5 Patrick St.,
Willoughby NSW 2068
Phone: 9417-2022
25.11.04

General Manager
Pittwater Council
(Attn Joanne Marshall - Planning Officer)

Re Proposed Rezoning 2,10,18,20,22 & 28 Ingleside Rd., Ingleside (Ref: R 0007/04)

Plan 'A'

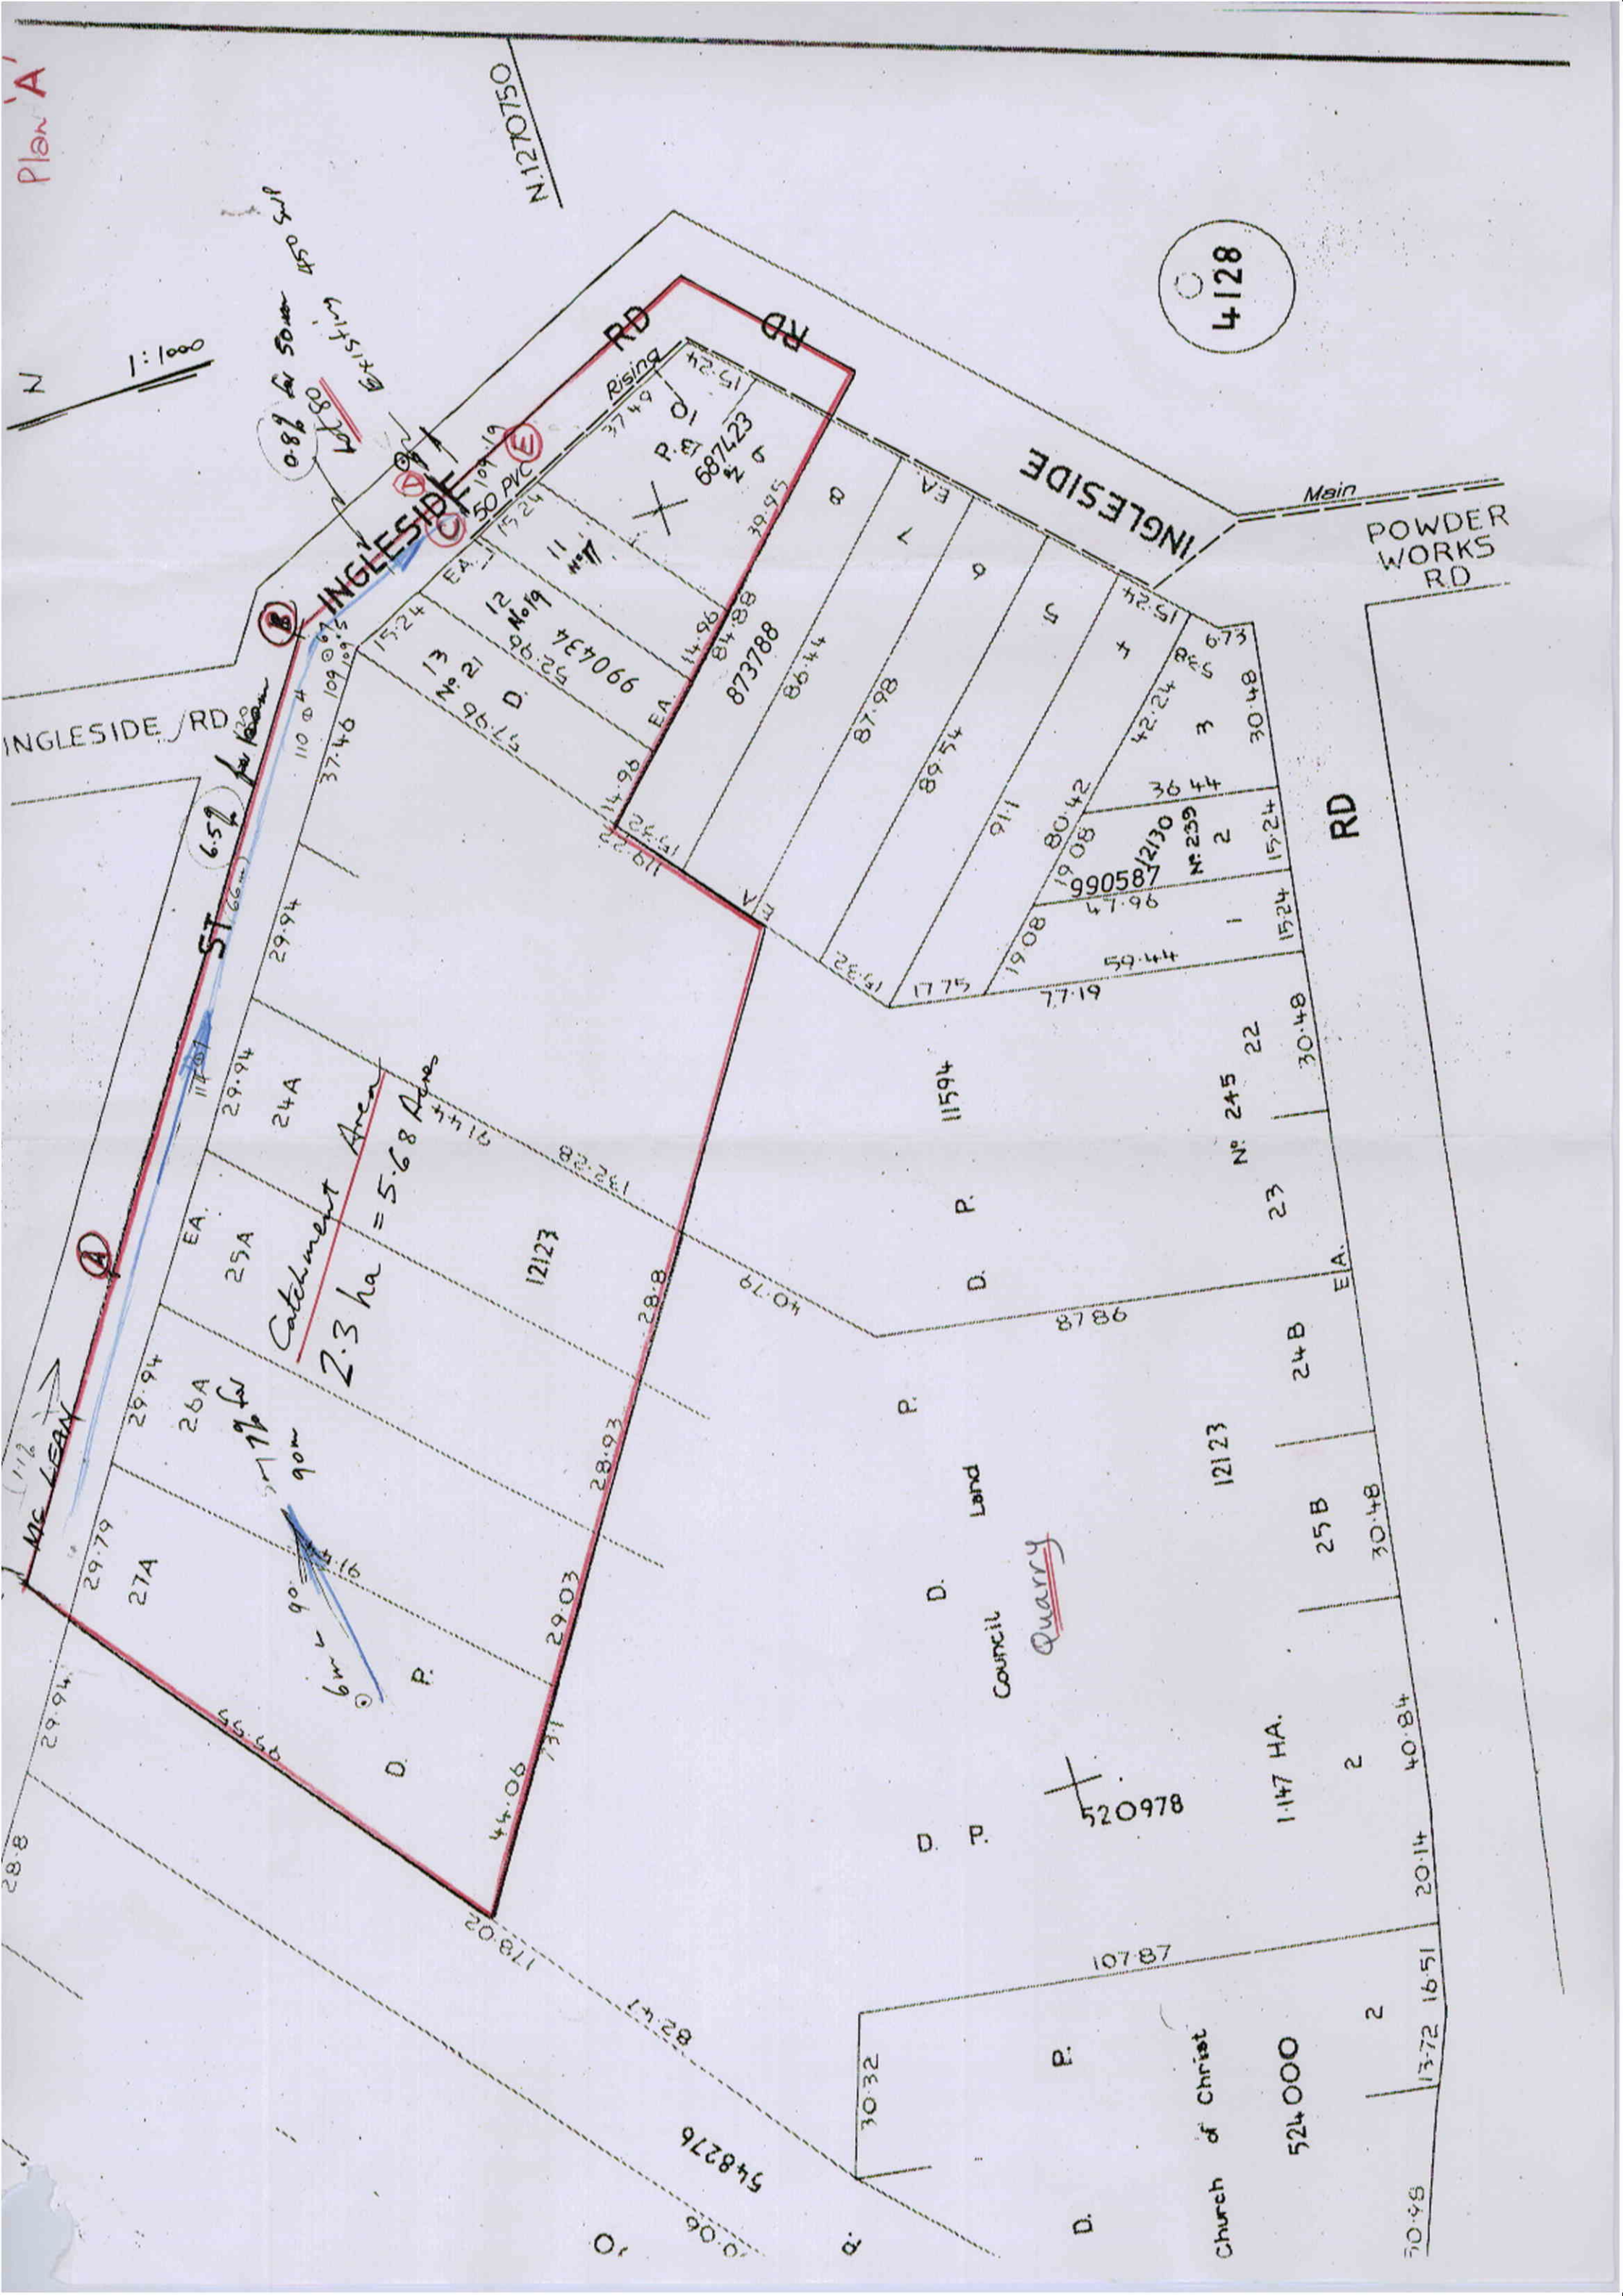
In May 2003, I observed the effects of two storms on the site. Runoff coming from the rear of the quarry land in McLean Street flowed along the southern side of the bitumen road in McLean Street in an easterly direction into Ingleside Road, where it headed south, i.e. 'A-B-C' on Plan 'A'. This flow is very fast as evidenced by the scouring on the southern side of the bitumen in McLean Street.

The gutter line on the southwest side of Ingleside Road and the entrance to the council's 450mm Stormwater Pipe at 'C' on Plans 'A' and 'B' are so poorly designed, constructed and maintained and blocked by the resident's driveways on the other side of the road to myself, i.e. Nos. 21 and 19, that 40 % of the flow which comes into Ingleside Road with such momentum from this direction bypassed the entrance to the council's 450mm Stormwater Pipe at 'C' and kept going to a point approximately at 'E' on plan 'B' where it met the flow coming along Ingleside Road from the south. This flow is also restricted from flowing along the gutter line which again is badly designed, constructed and maintained and blocked by the driveway of No. 17, so that it also cannot reach the entrance to the council's stormwater pipe at 'C'. The remaining 60% of the flow from the north flooded across the bitumen into the open drain between 'D' and 'F' on plan 'B'. It is just as well that this drain is left open. The original 40% flow from the north which collided with the restricted flow from the south at 'E' then crossed the road and because there is no gutter line on the eastern side of Ingleside Road at that point crossed the front of Lot 79 to my south and ran easterly on the southern side of my "sandstone filling for vehicular access" to my stables, to 'G' where I have built a gate.

PLAN 'B'

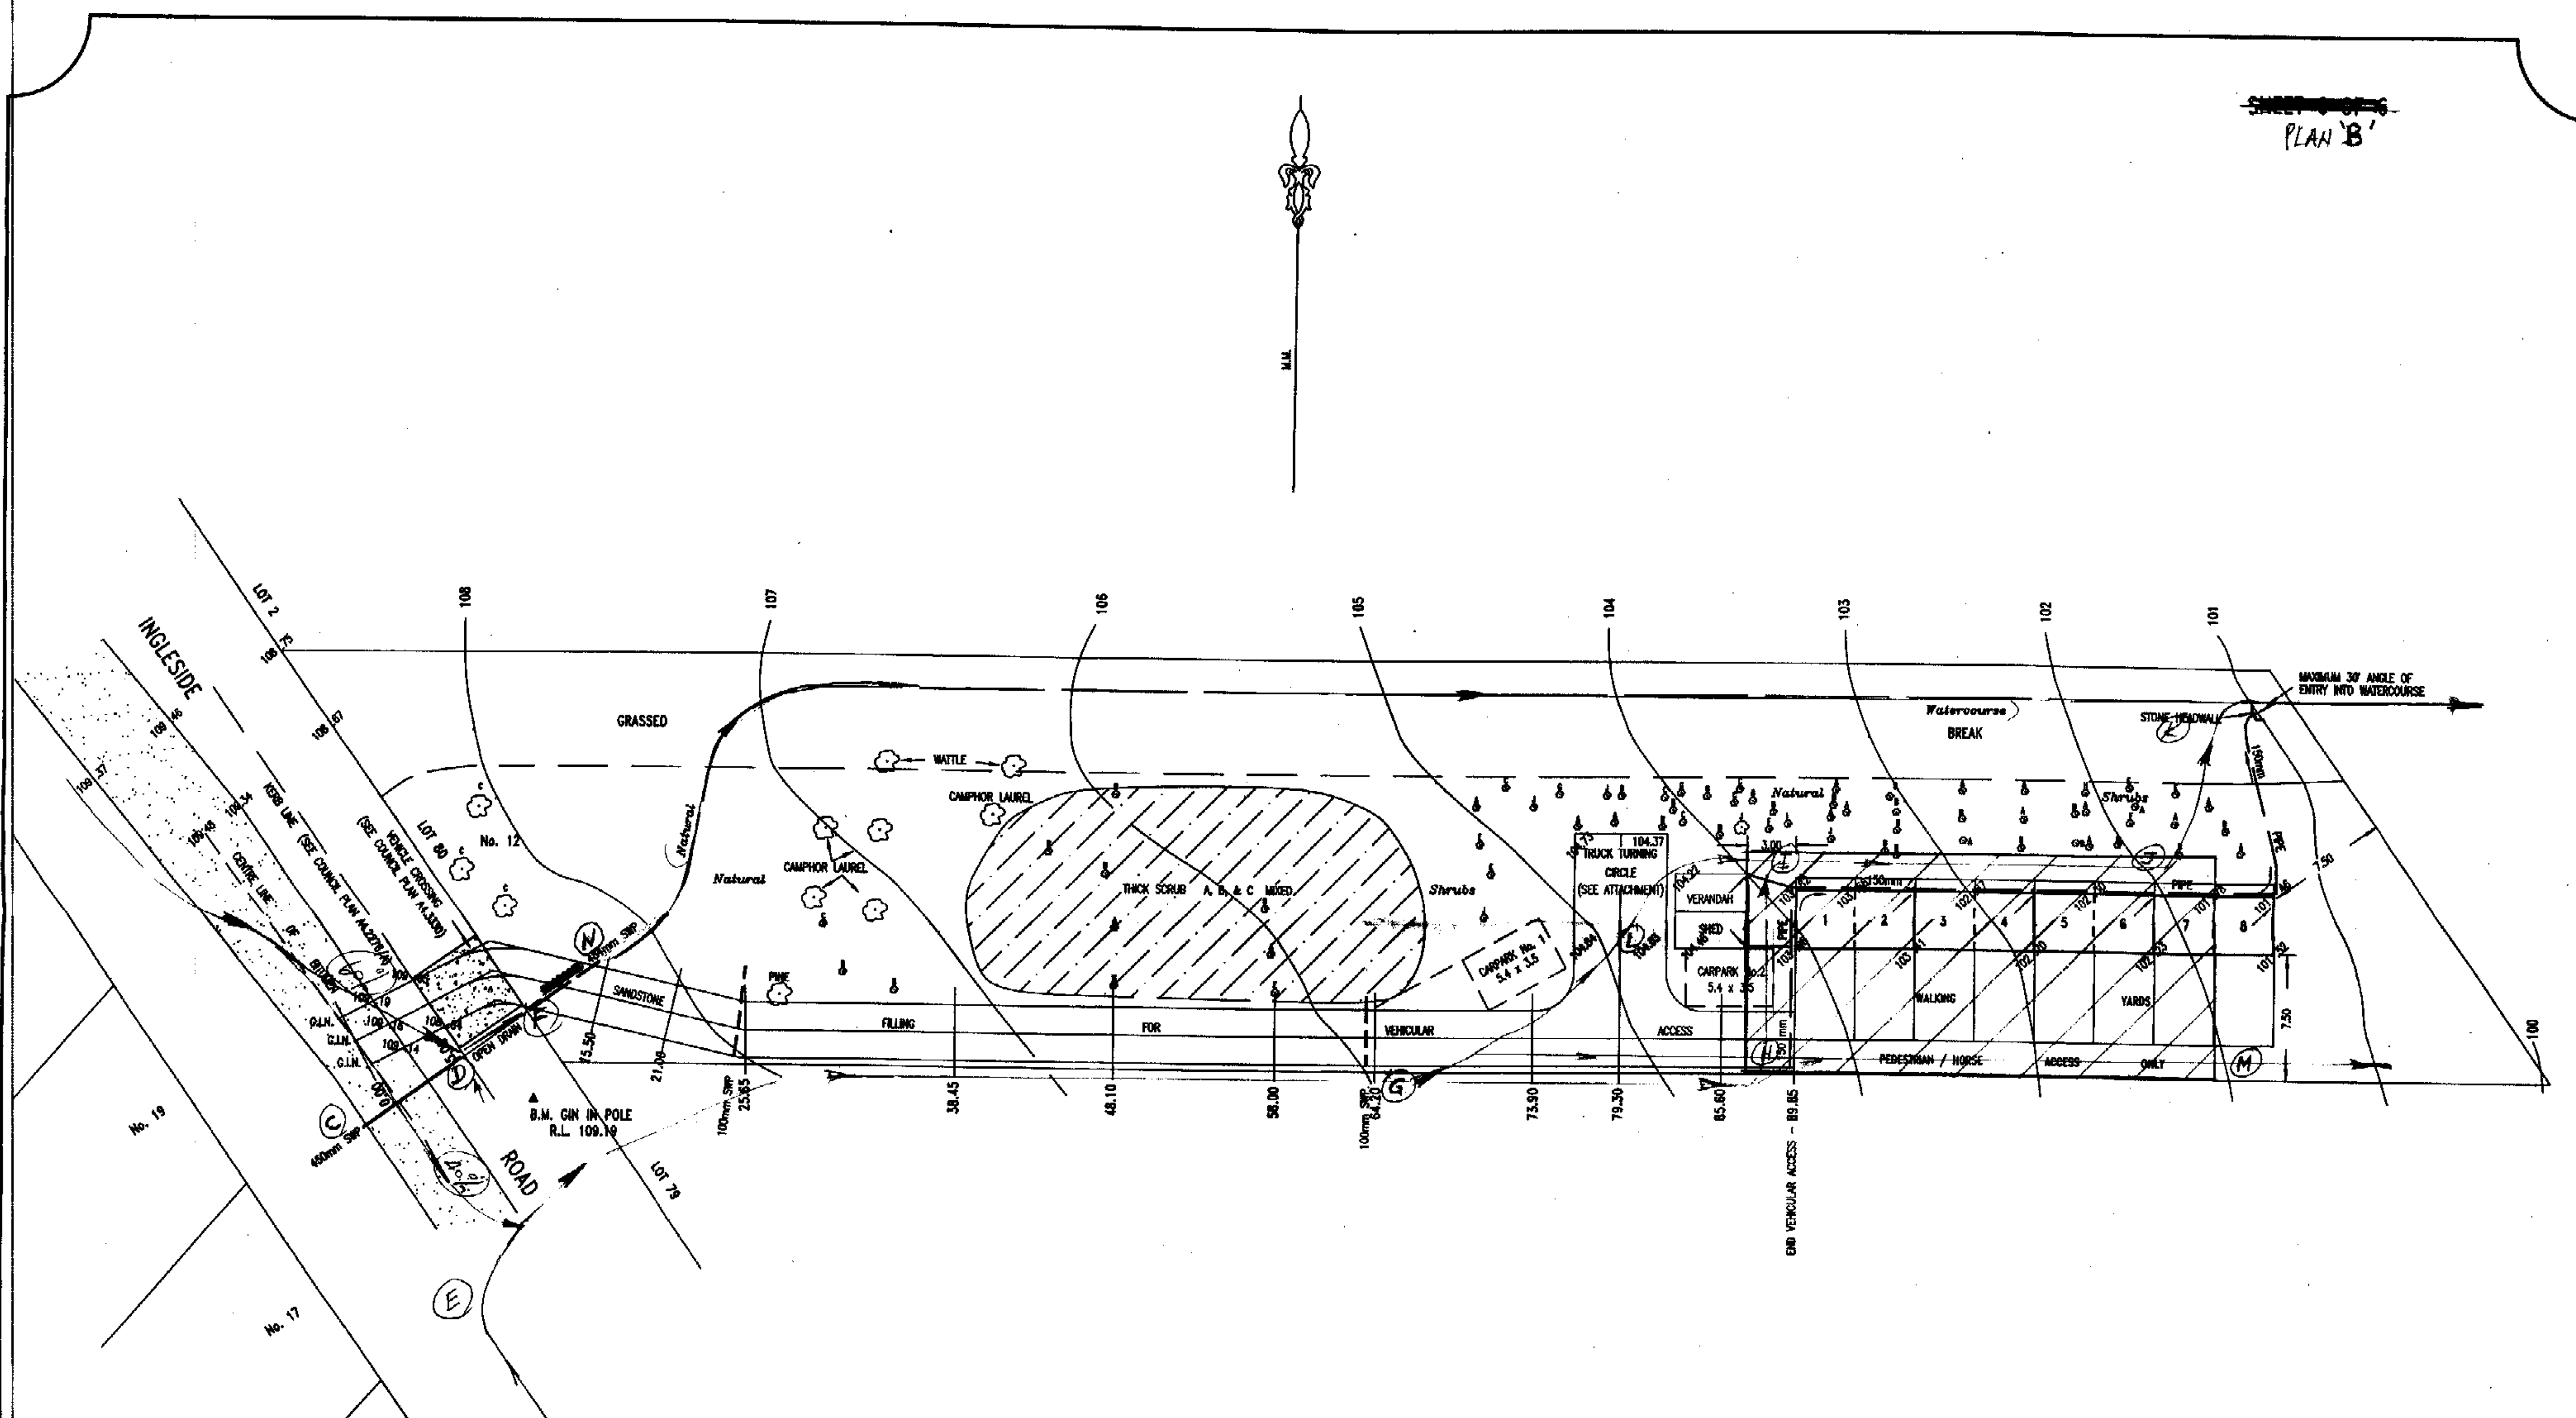
At this point the flow entered my property, where it split into three paths 'G-L-I', 'G-H-I-J-K' and 'G-H-M'.

This flow was very large, over the top of my boots, and stripped at least 40 tonnes of soil off this rear area of my block. The area shaded green on plan 'B' was devastated. The area hatched blue on Plan 'C' drains naturally to 'G' and the stable development was designed to cater for this runoff. In my opinion, it is the flooding caused by poor council infrastructure in Ingleside Road which caused this damage. The only relief I can provide in the future, is to pipe the water from 'G' to the natural creek along my northern boundary, where most of it belongs anyway.

During these storms this creek was running very fast with some scouring still evident. Most of this water, as mentioned above, entered the creek through the open drain in the council's footpath area at the front of my block in Ingleside Road. My 484mm Stormwater Pipe, 'F-N', stood up to the onslaught well as did the driveway itself.
